Application for Licence Amendment

Licence Number	L8907/2015/1
Licence Holder	Big Bell Gold Operations Pty Ltd
ACN	090 642 809
File Number	DER2015/001593
Premises	Cue Gold Operations – Day Dawn CUE WA 6640 Legal description – Mining tenements M21/7, M21/10, M21/14, M21/44, M21/65 and M21/89 As defined by the Premises maps attached to the Revised Licence
Date of Report	19/12/2024
Decision	Revised licence granted

Figure 1: Proposed landfill locations

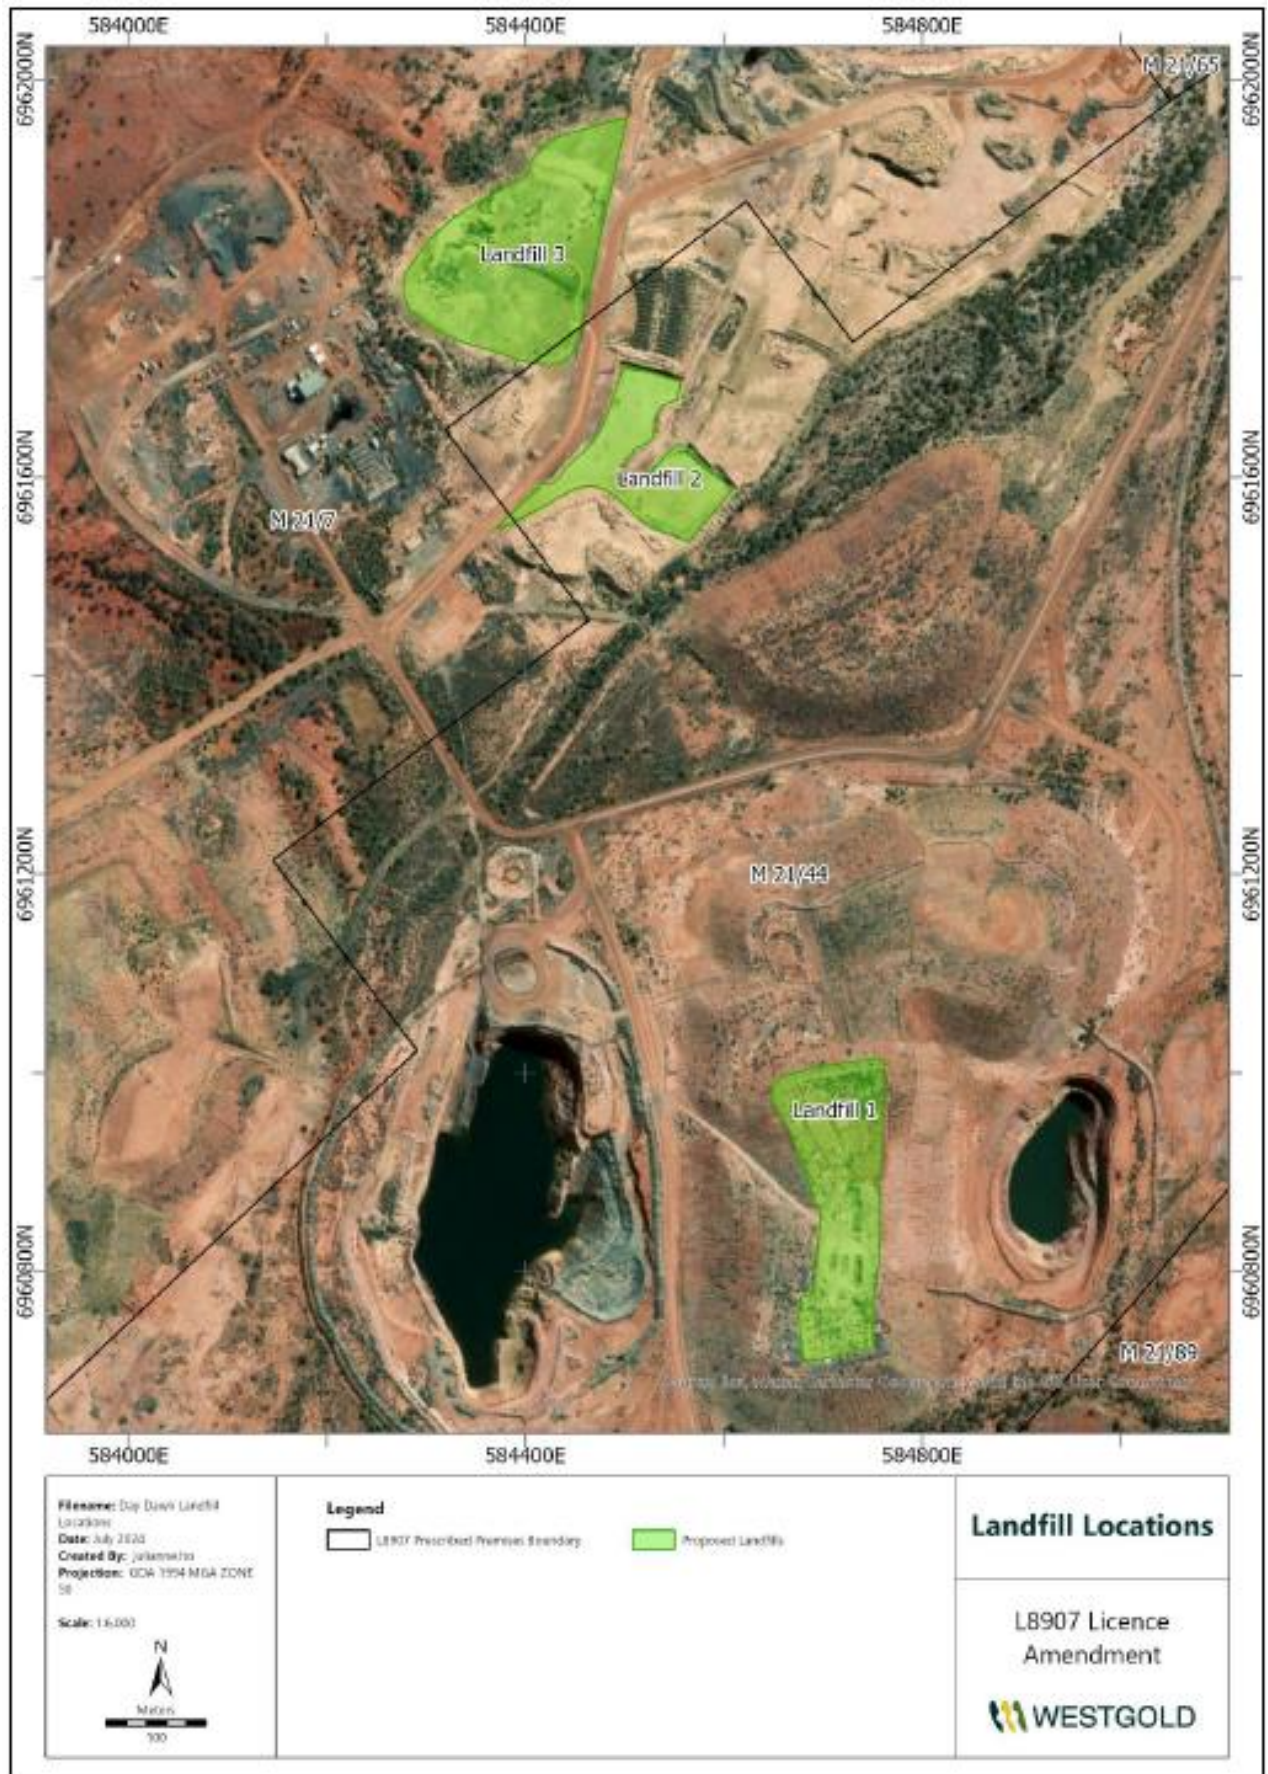
The Licence Holder is proposing to establish three separate landfill areas within the mining envelope within tenements M21/7 and M21/44. All three sites will be located within previously disturbed areas such as waste rock dumps and ex-tailing deposits. The first landfill is located on top of Try Again waste rock dump, of which the northern section has been historically used as a landfill. The two remaining proposed landfill areas are located within the Great Fingall Historic Tailings. The three proposed landfills will cover a total area of 6.86 hectares (ha). All activities are within previously disturbed areas.

The locations of the proposed landfills are shown within the premises boundary in Figure 1 below.

The three proposed putrescible landfill locations will be constructed at a designated sign-posted location using a trench system with the following constraints:

- Constructed landfill trenches will be 30 metres (m) length by 3m width by 4m depth;
- Windrows will be constructed around three sides of each trench to prevent stormwater ingress;
- Where specified, a fence will be installed surrounding the landfill area to create an effective barrier to fauna and minimise the likelihood of waste getting washed or blown off-site;
- Clear signage at the entrance to the facility will outline what waste is permitted to be disposed – all food and office waste will continue to be disposed off-site in the Cue Town landfill; and
- A rollover bund will be constructed at the entrance to the facility to prevent stormwater ingress.

4.2.3 (Table 4.2.2)	Removed the note to Schedule 2. Schedule 2 was removed in the previous amendment, but this note was not.
4.3.1 (Table 4.3.1)	Removed the note to Schedule 2. Schedule 2 was removed in the previous amendment, but this note was not.
Schedule 1: Maps	Included the map labeled Landfill Location Map as it is referenced in Table 1.2.3 of this licence.
